REMARKS

This is intended as a full and complete response to the Office Action dated April 26, 2004, having a shortened statutory period for response set to expire on July 26, 2004. Please reconsider the claims pending in the application for reasons discussed below.

FIG. 3

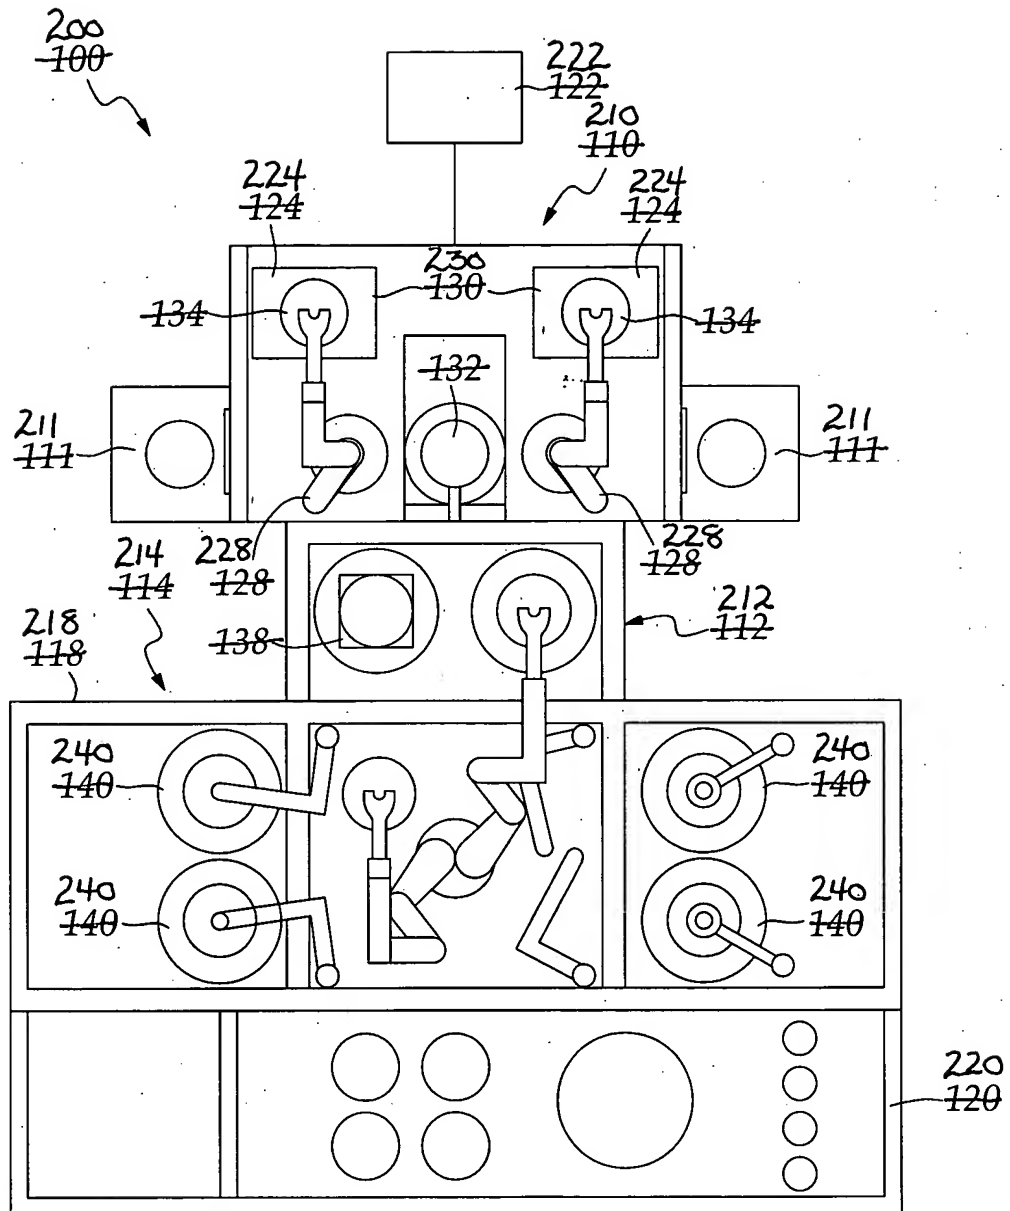
Additionally, amendments to Figure 3, and further amendments to Figures 2, 5, and 6 have been made to more clearly depict the figures as described in the specification. In Figure 3, reference numbers 100, 110, 111, 112, 114, 118, 120, 122, 124, 128, 130, and 140 have been amended to 200, 210, 211, 212, 214, 218, 220, 222, 224, 228, 230, and 240, respectively. In addition, reference numbers 132, 134, and 138 have been deleted. In Figure 2, an arrow pointing to element 211 has been added. In Figure 5, an erroneous designation of element 505 has been deleted. In Figure 6, the reference number for previously ambiguously labeled element 508 has been relocated to more clearly point out that element.

3. The reference numerals presented in Figure 3 were not defined in the specification, and the relationship between the information in Figure 3 and the information in Figure 2 was not clear. The reference numbers in Figure 3 have been amended to be consistent with Figure 2 and the text references in the specification as amended. Figure 3 as presently presented complementarily depicts the apparatus shown in Figure 2, as is described in the specification.

FIG. 5

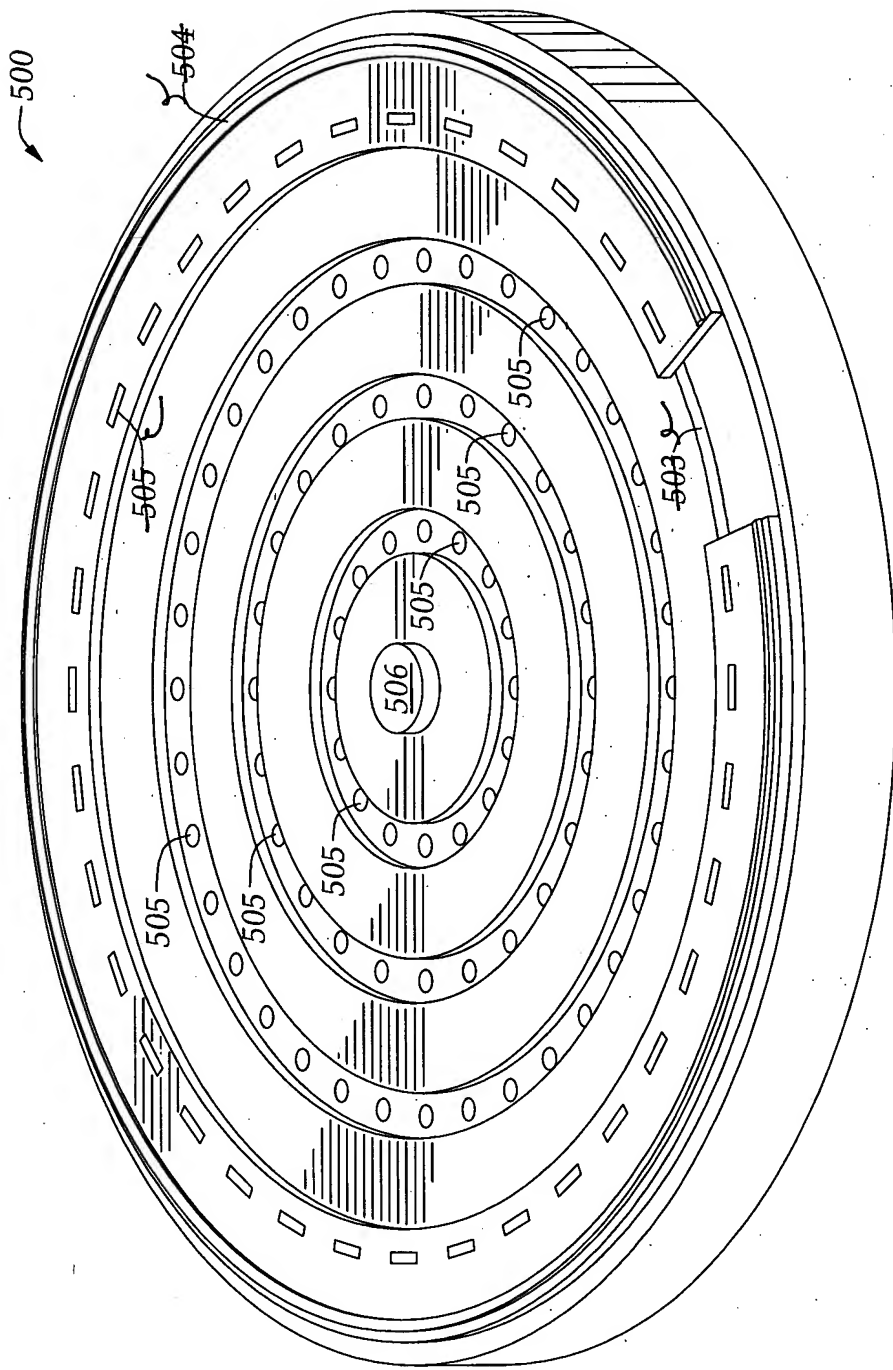
The drawings were objected to as failing to comply with 37 C.F.R. § 1.84(p)(5) because they do not include reference sign(s) mentioned in the description and/or include reference sign(s) not mentioned in the description. Figures 2, 4, 5, and 6 have been amended as required by the Examiner. In Figure 2, previously omitted reference numbers for elements 218 and 224 have been added, and the reference to mainframe transfer station 216 has been deleted from the specification. In Figure 4, previously omitted reference number 421 has been added. In Figure 6, omitted reference numbers for elements 510 and 511 have been added. Also in Figure 4, extraneous reference numbers 450, 452, 454, 456, 457, 458, 462, 464, 466, 467, and 468 have been deleted. Also in Figure 5, extraneous reference numbers for elements 503 and 504 have been deleted. Also in Figure 6, extraneous reference numbers 502, 503, 504, and 509 have been deleted.
